Powerhouse Ultimo Renewal Flooding Conditions

Ultimo Powerhouse Flooding conditions and proposed development effect

Further to the Department's request for information of 20 January 2023, the following information is provided to clarify information submitted in relation to flooding with the application. The below is in accordance with information submitted with Appendix V- Stage 1 Civil Report to the EIS, Appendix O- Civil Report to the Response to Submissions and subsequent information dated 2 November 2022.

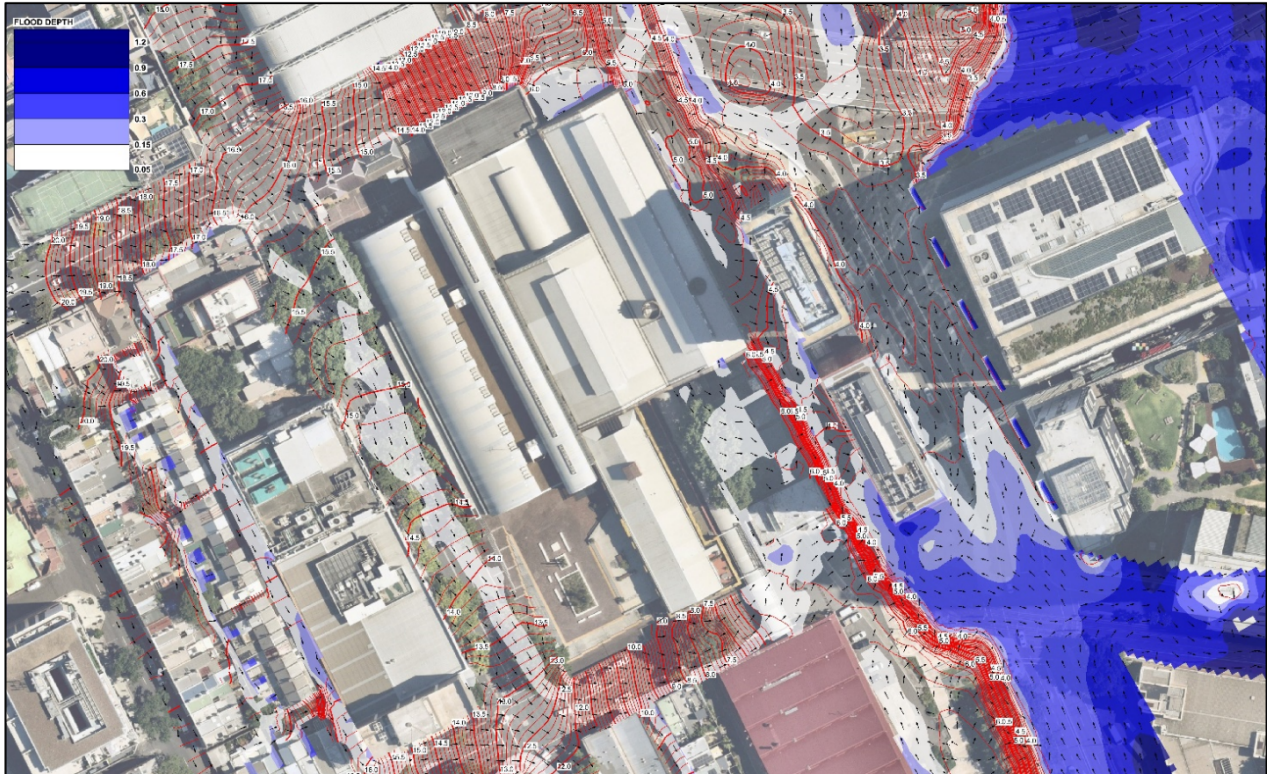
The powerhouse ultimo site is primarily affected by overland flow which complies with City of Sydney definition of Local Drainage flooding from page 14 of the COS Interim Floodplain Management Policy. This designation of the overland flow through the site on MacArthur Street will determine the treatment required for adjacent building levels and the entry to the basement.

The existing 1% flood condition is as per Figure 18

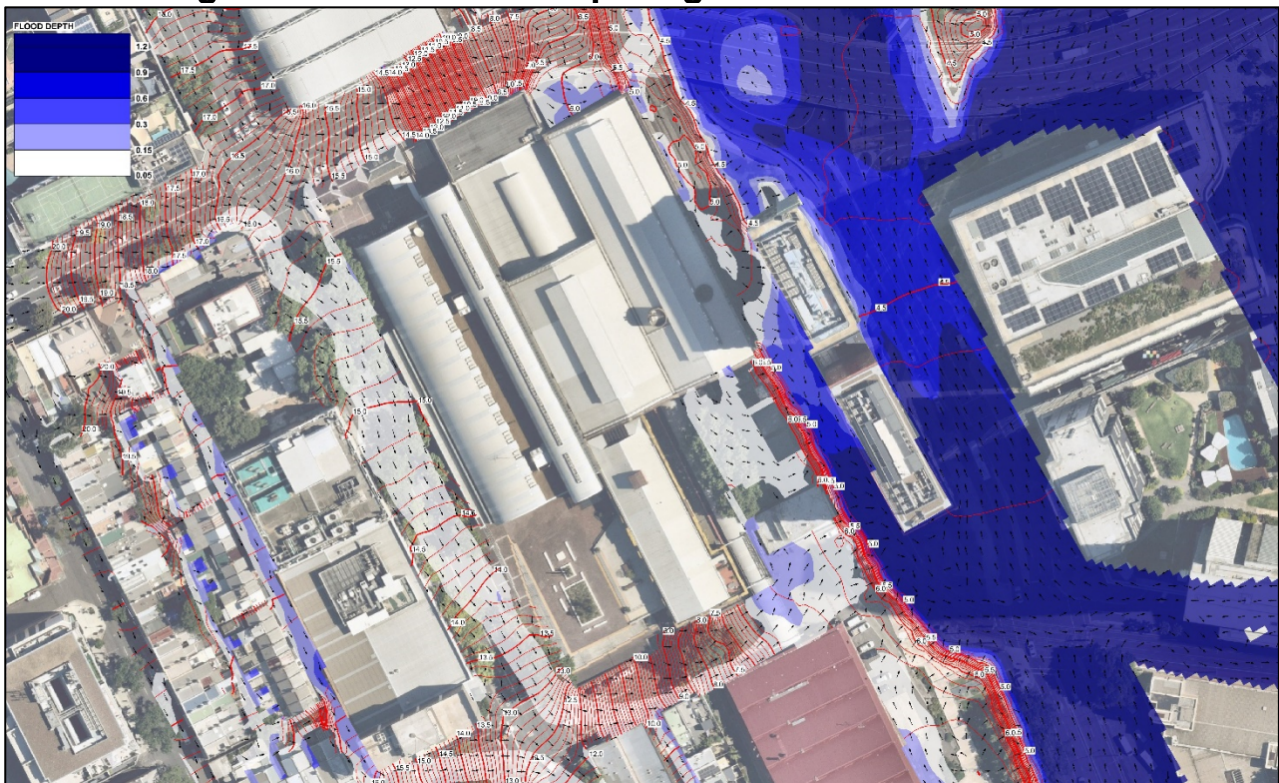
- **Macarthur Street** There is less than 150mm above the existing ground levels of flood or over land flow water depth.

- **Zone 3** inside the site there is 50-200mm above the existing ground levels of flood or over land flow water depth.

- **Zone 3** adjacent the site there is 50-200mm above the existing ground levels of flood or over land flow water depth.

The existing PMF condition is as per figure 19

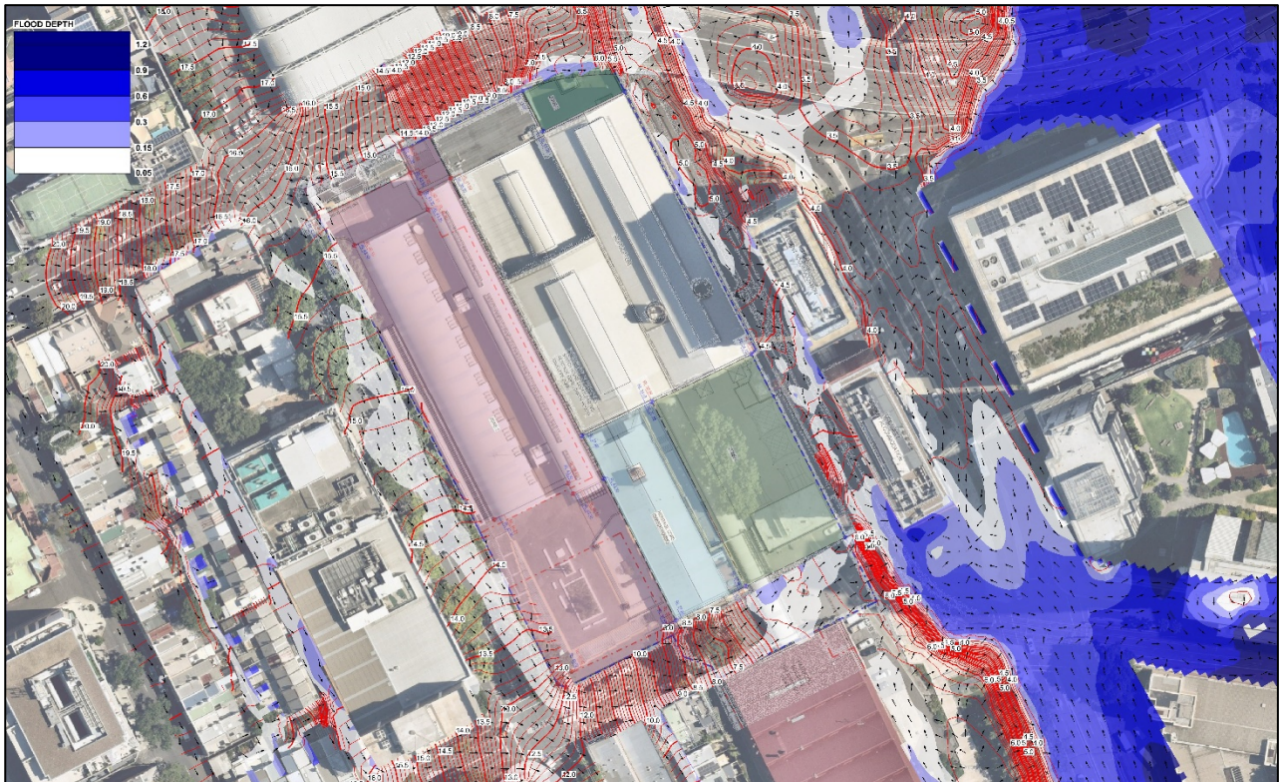
- **Macarthur Street** There is less than 150mm above the existing ground levels of flood or over land flow water depth, the extent is greater than the 1% AEP event but not significantly as these as small catchments. Please note the flooding of the light rail corridor and the Darling Drive are significantly increased.

- **Zone 3** inside the site there is 50-200mm above the existing ground levels of flood or over land flow water depth. the extent is greater than the 1% AEP event but not significantly as these as small catchments. Please note the flooding of the light rail corridor and the Darling Drive are significantly increased.

- **Zone 3** adjacent the site there is 50-200mm above the existing ground levels of flood or over land flow water depth. the extent is greater than the 1% AEP event but not significantly as these as small catchments. Please note the flooding of the light rail corridor and the Darling Drive are significantly increased.

The proposed 1% flood condition is as per Figure 25

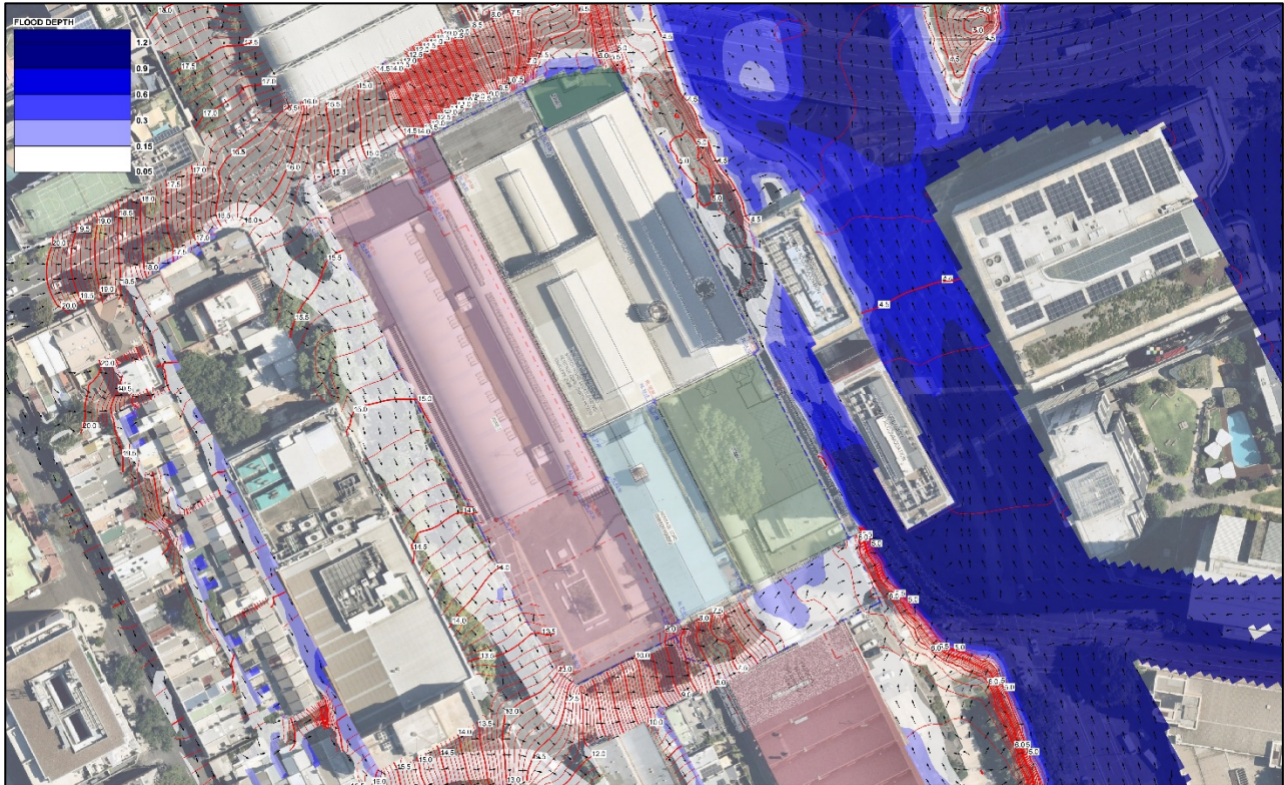
- **Macarthur Street** There is less than 150mm above the existing ground levels of flood or over land flow water depth and flooding has been removed from the new building envelope area.

- **Zone 3** inside the site Flooding has been removed from the new building envelope area.

- **Zone 3** adjacent the site there is 50-200mm above the existing ground levels of flood or over land flow water depth, which is slightly worse than the existing condition but local to the zone adjacent the proposed building. There are no significant upstream effects. Some local drainage infrastructure will be required to address this local flood worsening.
